SUNDRY NOTICES AND REPORTS ON WELLS ab

SUBMIT IN TR	7. If Unit or CA/Agreement, Name and/or No. 891000303X		
1. Type of Well Oil Well Gas Well Oth	her		8. Well Name and No. POKER LAKE UNIT CVX JV PC 19H
Name of Operator BOPCO LP		: WHITNEY MCKEE ee@basspet.com	9. API Well No. 30-015-42669-00-X1
3a. Address P O BOX 2760 MIDLAND, TX 79702	٠٠	3b. Phone No. (include area code) Ph: 432-683-2277	10. Field and Pool, or Exploratory UNDESIGNATED
4. Location of Well (Footage, Sec., 7	C., R., M., or Survey Descript	ion)	11. County or Parish, and State
Sec 21 T24S R30E NWNE 25 32.123702 N Lat, 103.530566		•	EDDY COUNTY, NM

PLU CVX JV PC #019H BHL, Production Hole Size, Casing Design and Cement Volume

WELL LOCATION AND ACREAGE DEDICATION PLAT

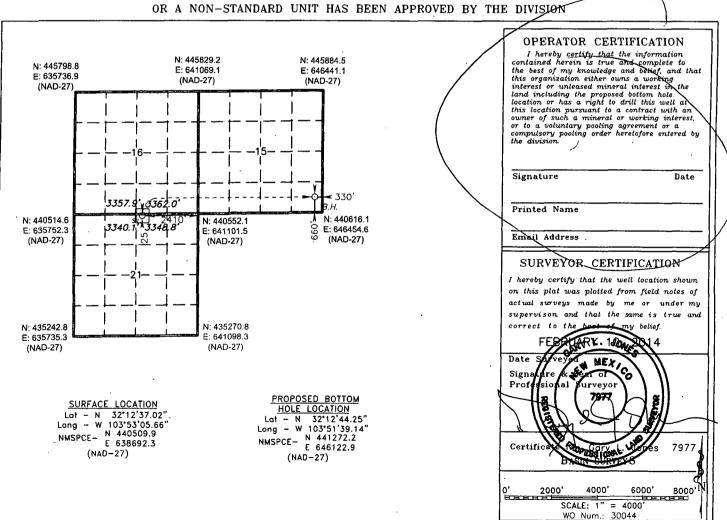
BOPCO, L.P. respectfully request to change the BHL to 660? FSL and 1960? FEL in Sec 14, T24S-R30E. BOPCO is now requesting the BHL be changed to 660? FSL and 330? FEL in Section 15, T24S-R30E.

UL or lot No.	Section	Township	Range	Lot Idn	FEET from the	North/NORTH LINE	FEET from the	East/EAST LINE	County
0	15	24 S	30 E	·	660	SOUTH	330	EAST	EDDY
Dedicated Acres	s Joint o	r Infill Co	nsolidation	Code Or	der No.				
	1				3		•
